UNITED STATES PATENT AND TRADEMARK OFFICE

10/699,604

Office Action Summary	Application No.	Applicant(s)	
	10/699,604	EVANGELIDES ET AL.	
	Examiner	Art Unit	
	David S. Kim	2613

DETAILED ACTION**Drawings**

**FIG. 5**

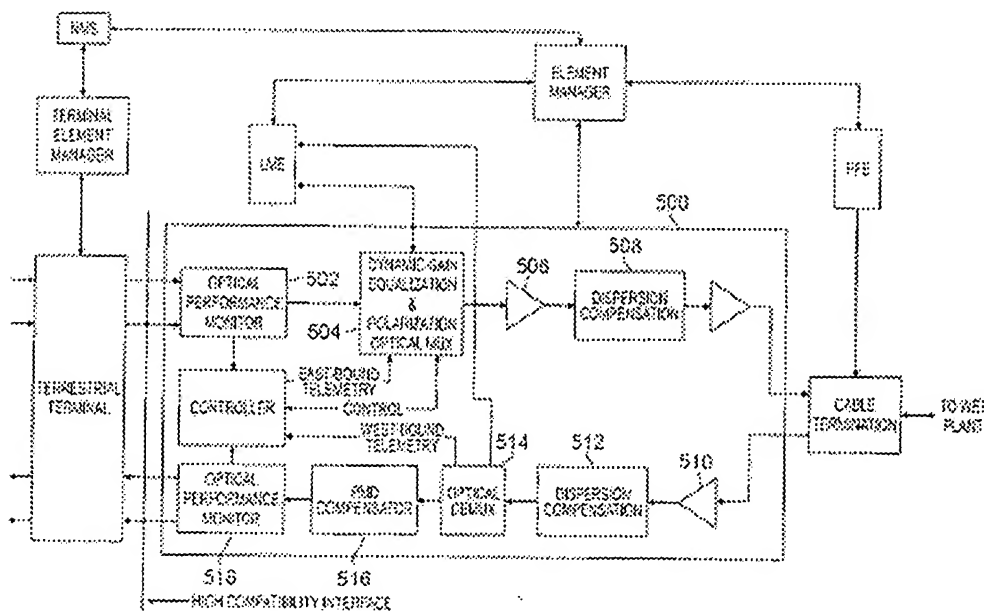
In the original disclosure, the specification states that Fig. 4 shows an embodiment of the optical interface device shown in U.S. Application Serial No. 10/621,028. Note the corresponding embodiment in Fig. 5 from U.S. Application Serial No. 10/621,028.

Fig. 4 from the instant application is very similar to Fig. 5 from U.S. Application Serial No. 10/621,028. Clearly, Fig. 5 from U.S. Application Serial No. 10/621,028 corresponds Applicant's Fig. 4 of the instant application. Again, clearly, Fig. 5 from U.S. Application Serial No. 10/621,028 does not show Raman pump source 507 and the connection from 507 to the line between 505 and 522. Accordingly, Applicant's amendment to Fig. 4 is not supported, and Applicant's amended Fig. 4 is disapproved.

FIG. 2

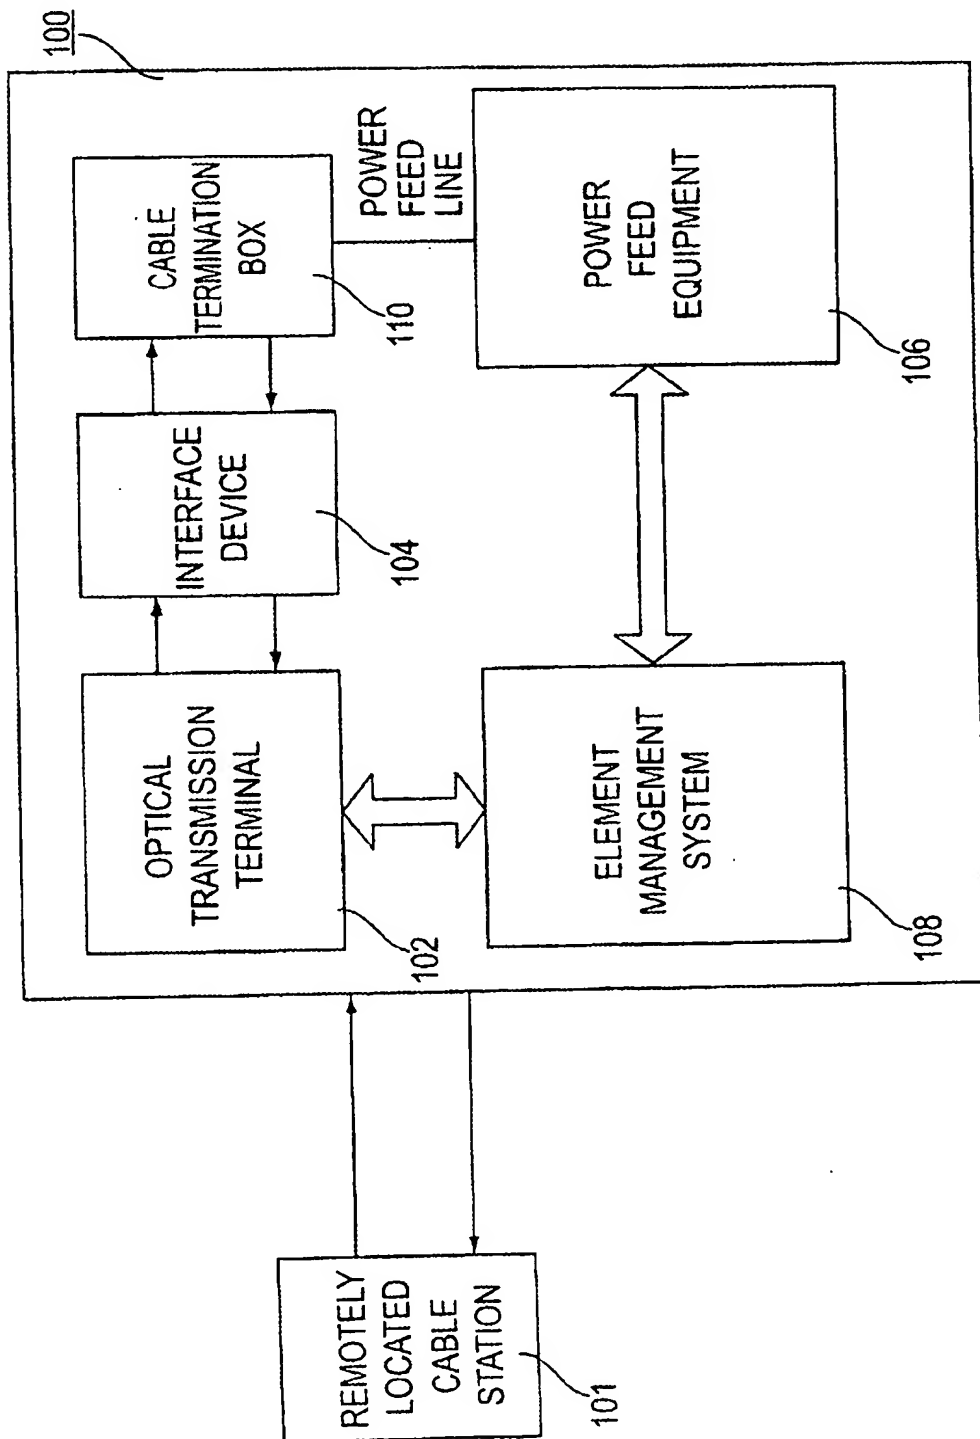
- The replacement drawing for Fig. 2 is disapproved. Although the amended Fig. 2 itself is acceptable, this drawing is objected to as failing to comply with 37 CFR 1.84(p)(5) because it includes the following reference character not mentioned in the description: 101.
- The replacement drawing for Fig. 4 is disapproved. Applicant amended Fig. 4 of the instant application to include Raman pump source 507 and the connection from 507 to the line between 505 and 522. However, the original disclosure does not support Applicant's amendment.

*Disapproved by DSK
06 September 2006*

2. Corrected drawing sheets in compliance with 37 CFR 1.121(d) are required in reply to the Office action to avoid abandonment of the application. Any amended replacement drawing sheet should include all of the figures appearing on the immediate prior version of the sheet, even if only one figure is being amended. The figure or figure number of an amended drawing should not be labeled as "amended." If a drawing figure is to be canceled, the appropriate figure must be removed from the replacement sheet, and where necessary, the remaining figures must be renumbered and appropriate changes made to the brief description of the several views of the drawings for consistency. Additional replacement sheets may be necessary to show the renumbering of the remaining figures. Each drawing sheet submitted after the filing date of an application must be labeled in the top margin as either "Replacement Sheet" or "New Sheet" pursuant to 37 CFR 1.121(d). If the changes are not accepted by the examiner, the applicant will be

FIG. 4

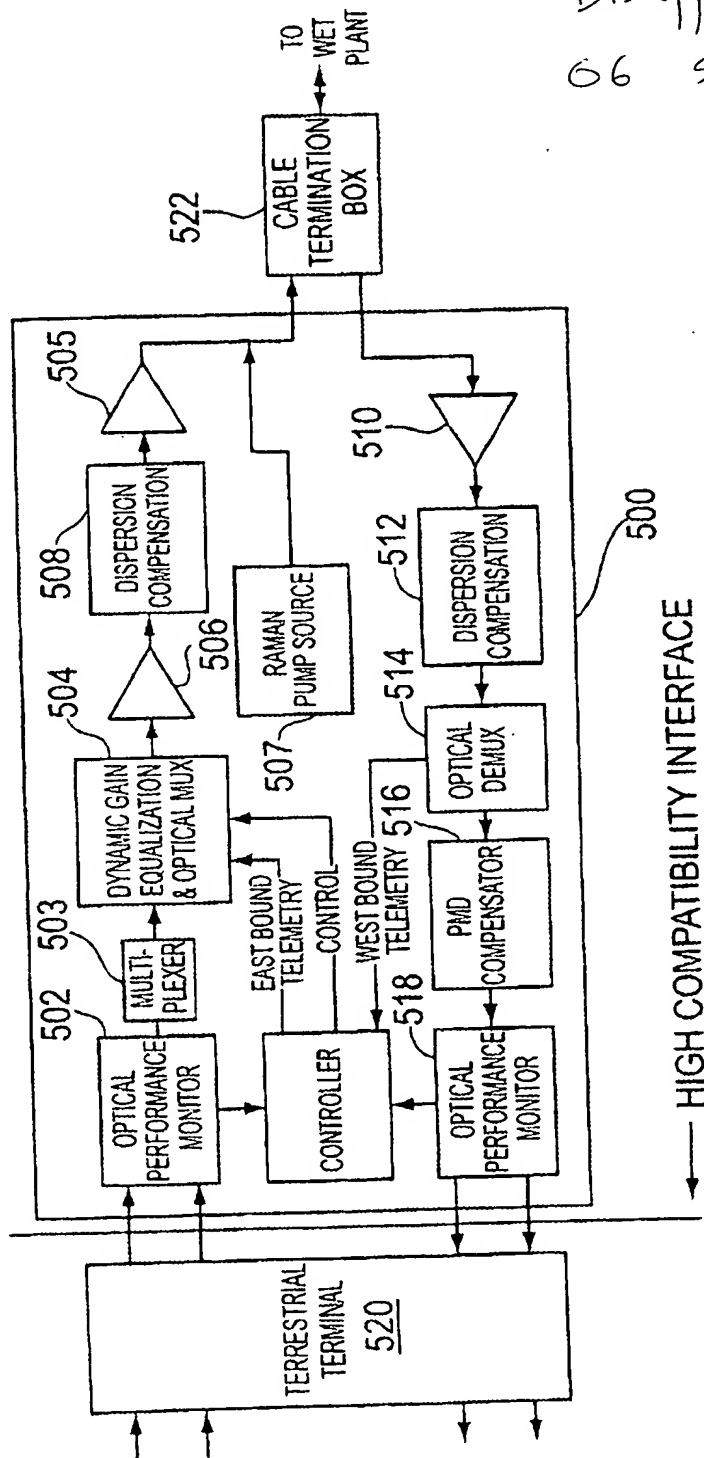
Moreover, even if one could reasonably argue that the embodiment of Fig. 4 may support the inclusion of Raman pump source 507, the connection from 507 to the line between 505 and 522 is not supported by the original disclosure.

- Although original claims 10, 20, 32, and 44 do disclose "means for supplying pump power to impart Raman amplification to the optical signals", drawing such means in the embodiment of Fig. 4 is not supported. On the other hand, these means may be supported in another drawing (not Fig. 4) of another embodiment of the interface device. Still, as these means are not provided in any approved drawing, the drawings are objected to under 37 CFR 1.83(a). The drawings must show every feature of the invention specified in the claims. Therefore, the "means for supplying pump power to impart Raman amplification to the optical signals" must be shown or the feature canceled from the claims 10, 20, 32, and 44. No new matter should be entered.

Disapproved by DSK
06 september 2006
